**1. Fisheries and Oceans Canada Original Comment:**

Section 1.2 Proposed Project modifications (page 5) Section 2.2 Planned Activities for 2016 (page 8) and Section 2.3.2 Increased Number of Wells (page 10) – Further to comments provided on January 15, 2015 arising from review of the Statoil EA Update for 2016 the proponent should indicate the probable drilling / well locations planned for 2016 – 2019 especially whether or not any such wells will be located within or near any of the NAFO Vulnerable Marine Ecosystem (VME) areas or other sensitive marine areas depicted in Appendix A – Figure 1.

Figure 3: Location of Special Sensitive Areas in Relation to Project Area

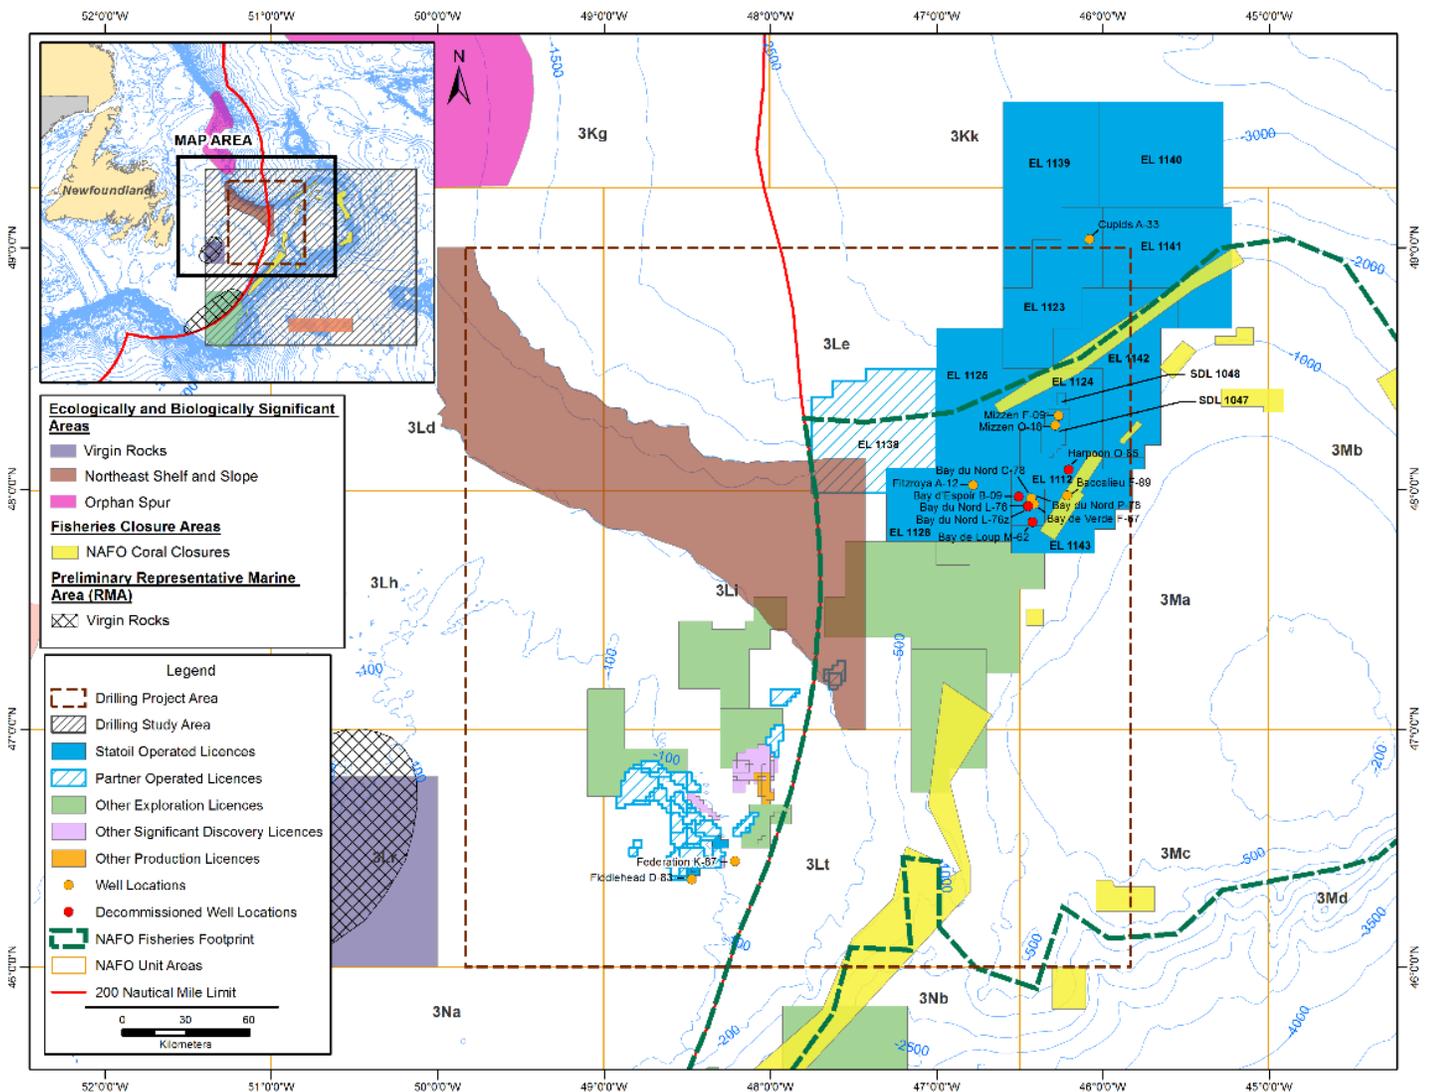
While the response and the revised section in the December 2016 EA Amendment provide a very good summary description of VMEs and sensitive marine areas within the project area, the response / description has not fully addressed our comment. More specifically there has been no "...indication whether drilling activities have occurred within or near such areas". To fully address our previous comment, it is felt that wellhead location information presented in Figure 2 (page 6 December 2016 EA Amendment) should be included within Figure 3 Location of Special / Sensitive Areas in Relation to Project Area (page 17 December 2016 EA Amendment).

The following figure replaces Figure 3 in the EA amendment. It identifies the wells drilled by Statoil and the locations of wells decommissioned in 2016.
